REPLACEMENT SHEET

U.S. SERIAL No.: 10/056,316

TITLE: ENDPOINT DETECTION FOR ELECTRO CHEMICAL MECHANICAL
POLISHING AND ELECTROPOLISHING PROCESSES

Fig. 1

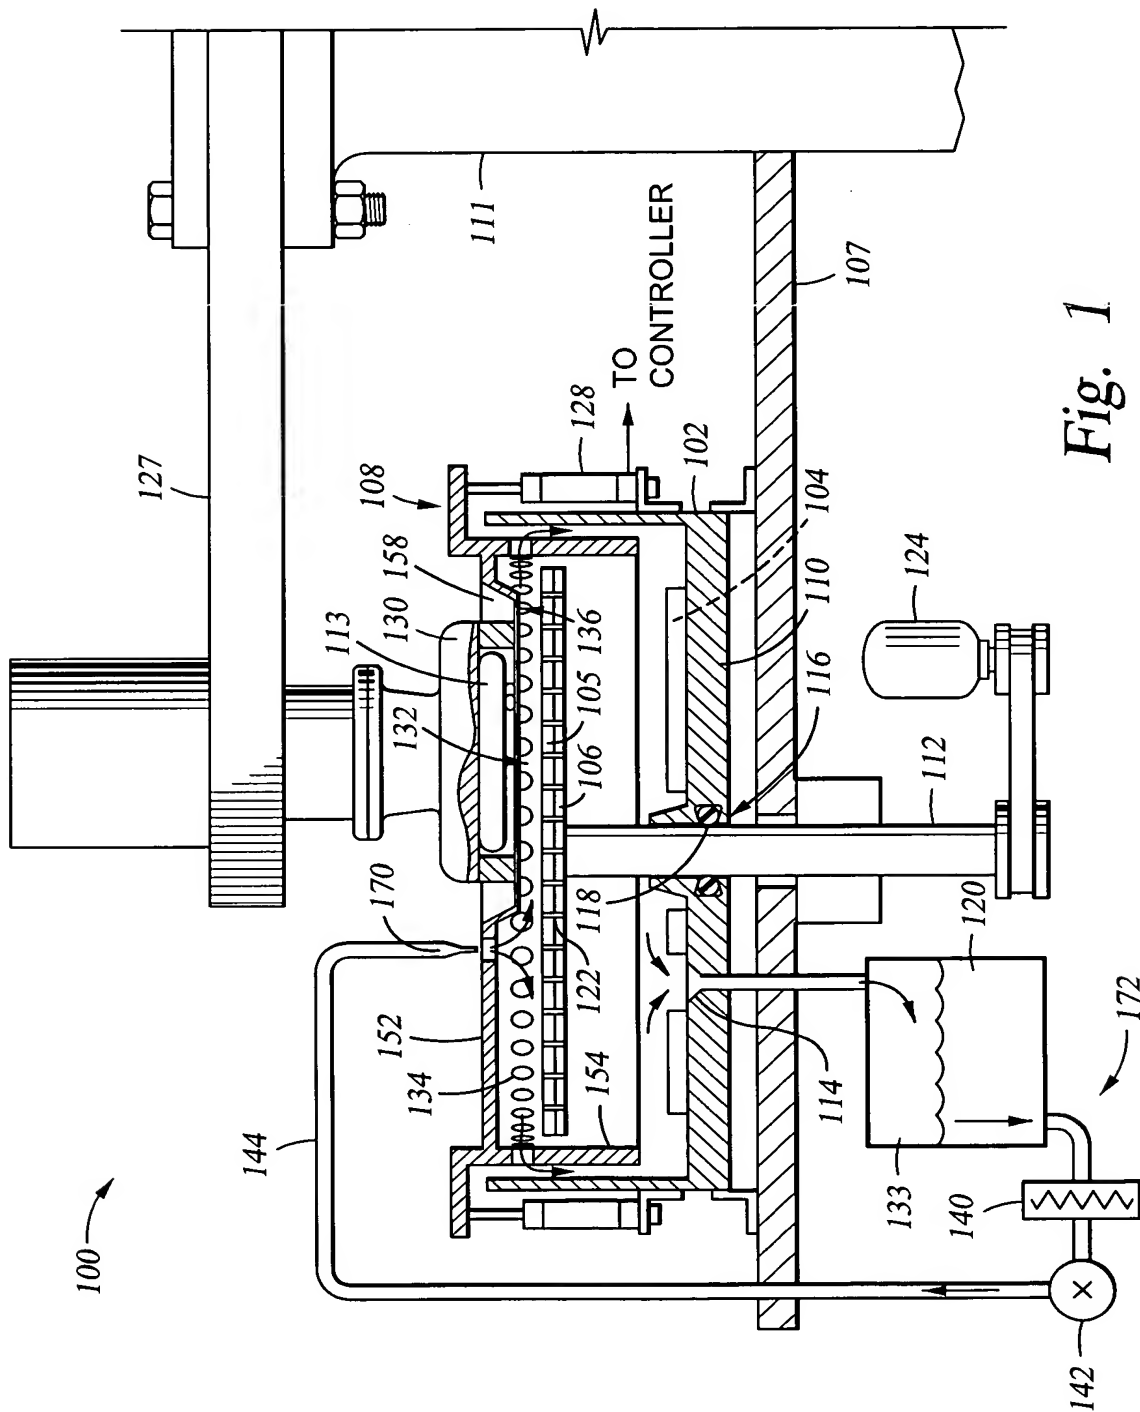
The attached sheet of drawings shows changes to Figure 1. Particularly, Applicants have deleted the reference sign "140" positioned below the words "TO CONTROLLER." That reference sign is out of place and an obvious drafting error.
